Dowdens Station, LMA G-957, Preliminary Forest Conservation Plan and Preliminary Water Quality Plan

Staff Report Date: 6/26/2015

Dowdens Station Local Map Amendment: G-957
B. Preliminary Water Quality Plan
C. Preliminary Forest Conservation Plan

Request for a Local Map Amendment for reclassification of a 24.37-acre property from R-200 Zone to PD-4 Zone, for the development of up to 105 detached and attached single-family dwelling units, located on the west side of Frederick Road (MD 355), 1,300 feet north of its intersection with Shawnee Lane, known as Garnkirk Farms Parcel N760, part of Lot 21 and Parcel N888 Lot 22 tax map EW31, Clarksburg, 1994 Clarksburg Master Plan and Hyattstown Special Study Area.

PRELIMINARY WATER QUALITY PLAN

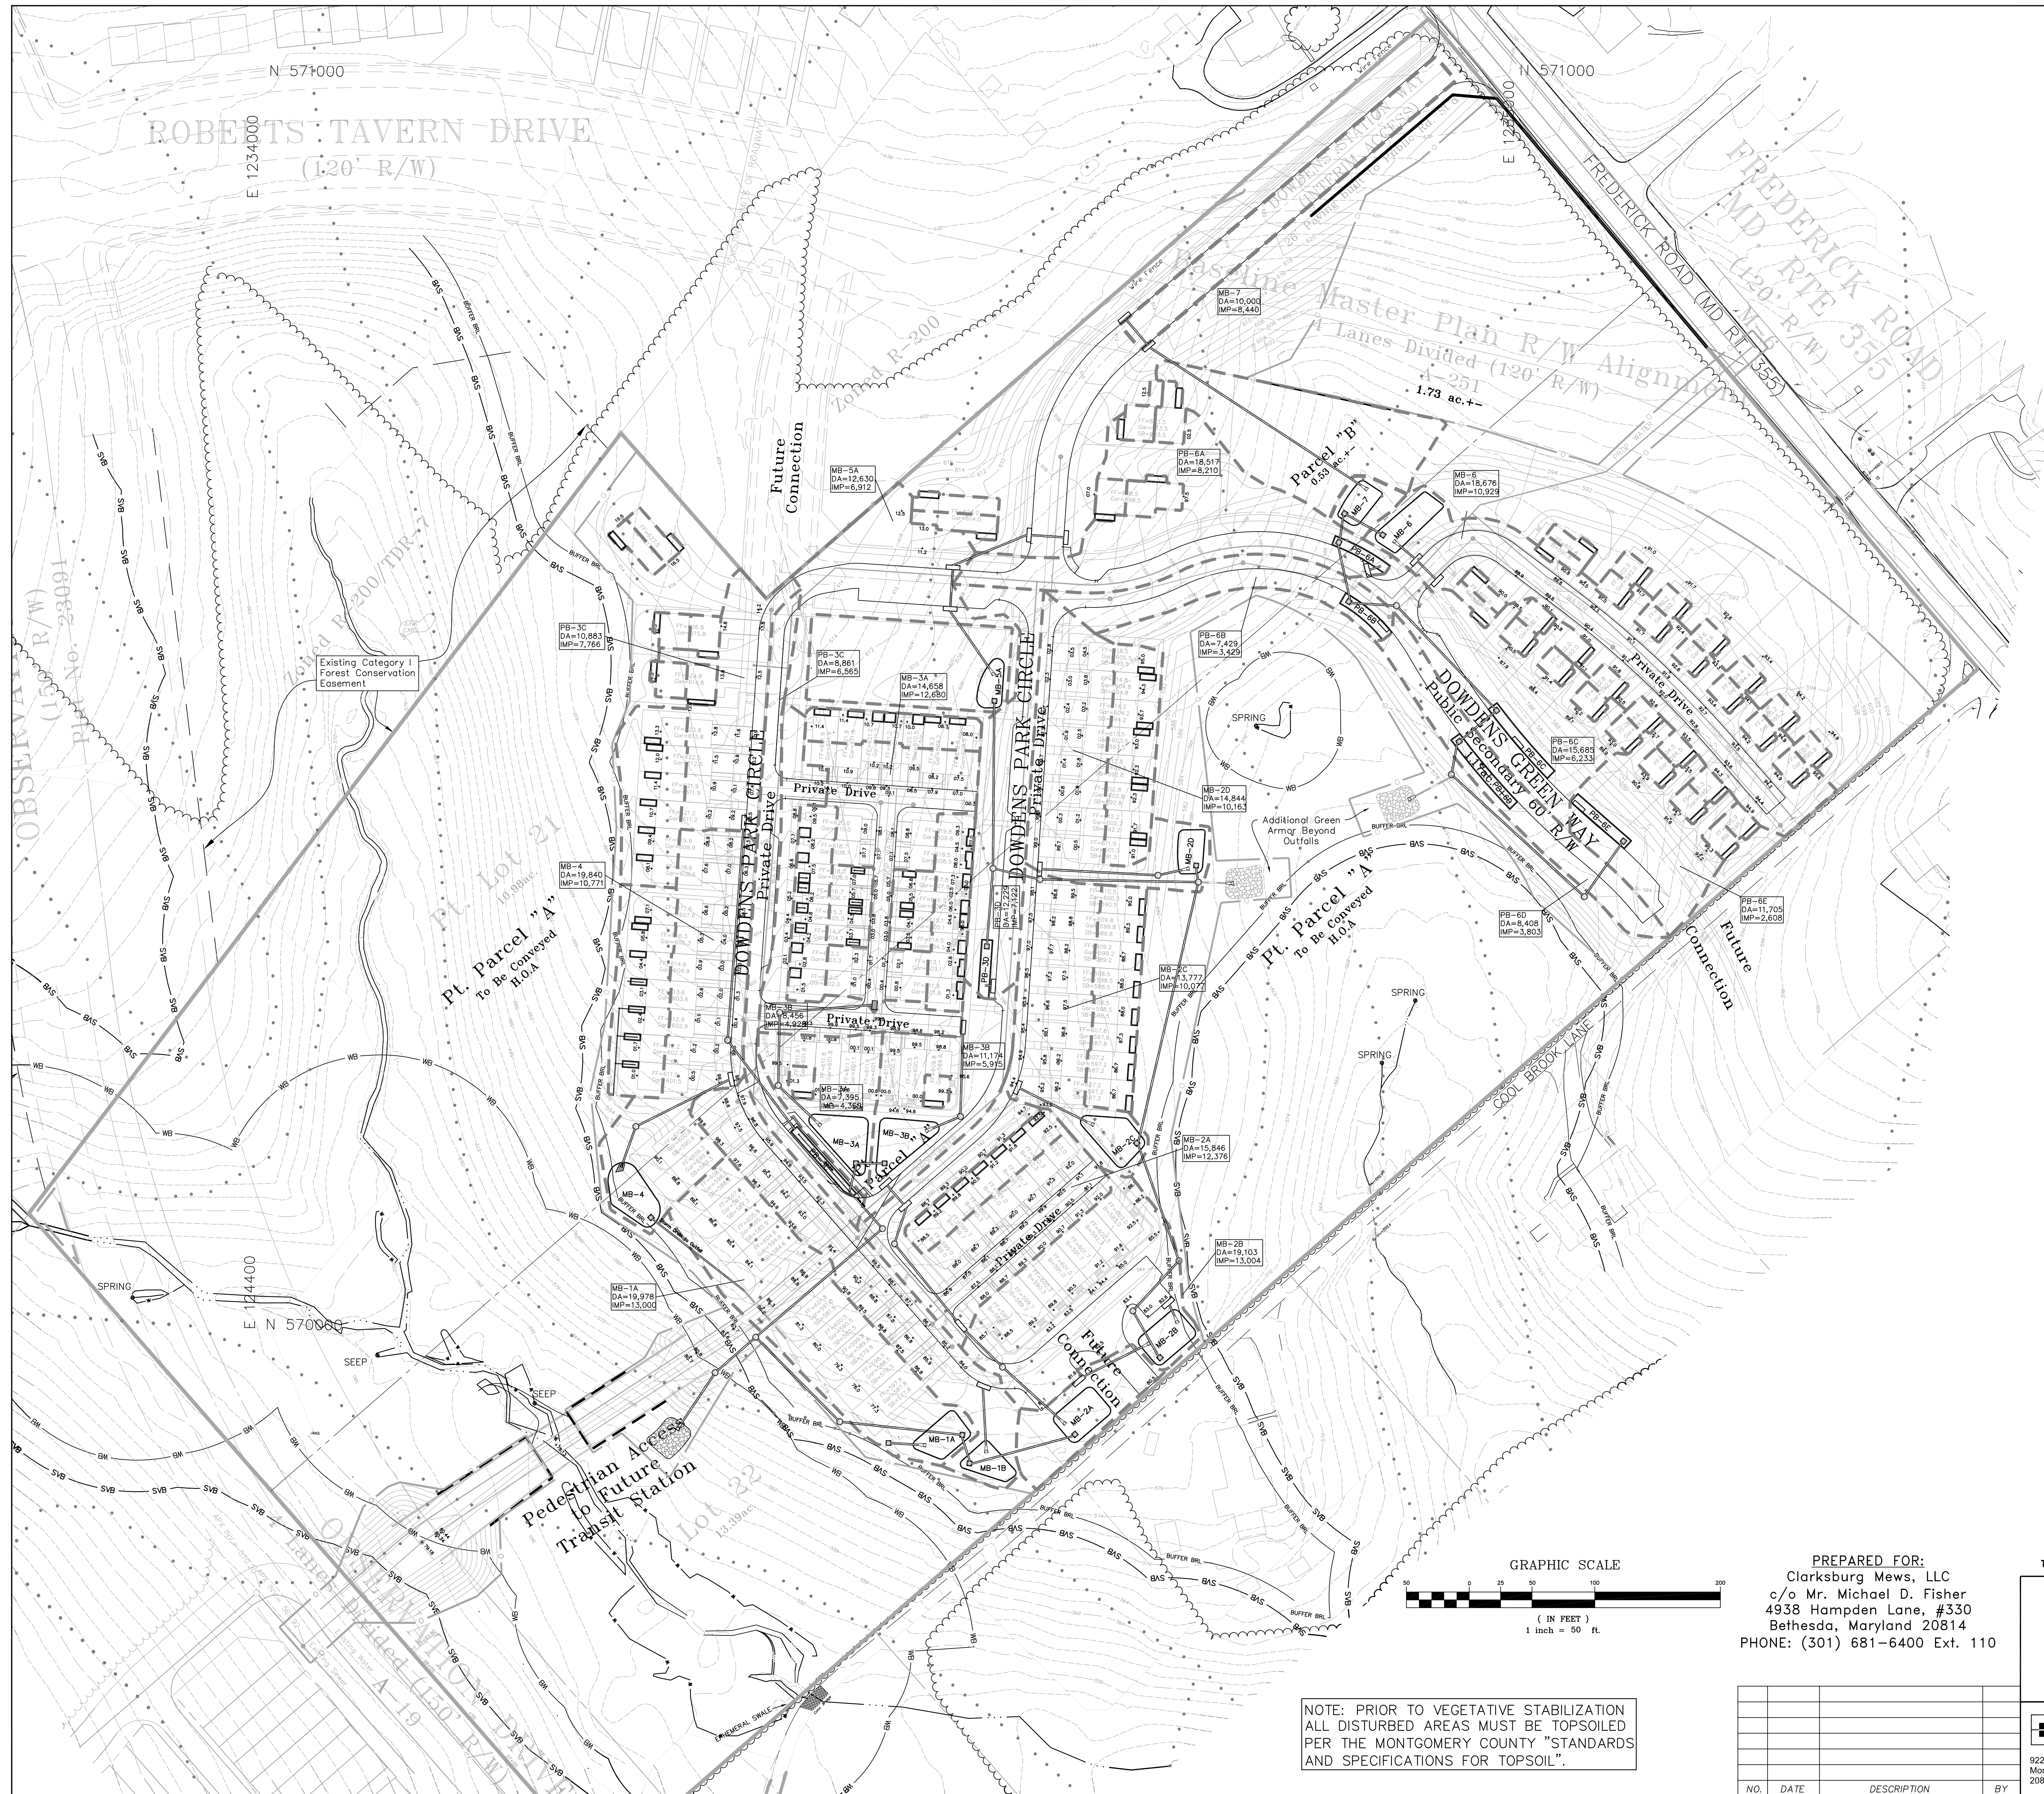
The conditions may impact the Planning Board's part of the review of the water quality plan. For example, the fourth condition, "Provide safe non-erosive outfalls into the proposed green/HOA areas. It appears that the outfall located in the area near the pedestrian access to the future transit station may need to be moved further down slope." Compliance with this condition will result in more priority forest removal and wetland impact.

Other impacts to the environmental buffers are less direct. In order to build and engineer Dowdens Green Way around the second stream and an associated wetland on the site there will be a 10-20-foot grade change on three sides of the wetland and stream system, requiring retaining walls. However, the stream buffer will not be directly impacted. One of the purposes of the PD zone is to “minimize the amount of grading necessary for construction of a development.” Grading and the use of large retaining walls should be minimized.

1. Approved stormwater management plan and sediment control plan must conform to the limits of disturbance of the preliminary forest conservation plan.
2. Impervious levels must not exceed 30 percent of the net tract area.
3. The arch culvert stream crossing must not impact wetlands or their buffers and must minimize impacts to the natural flow of the stream.
4. Minimize height of retaining walls separating sensitive areas from developed areas.
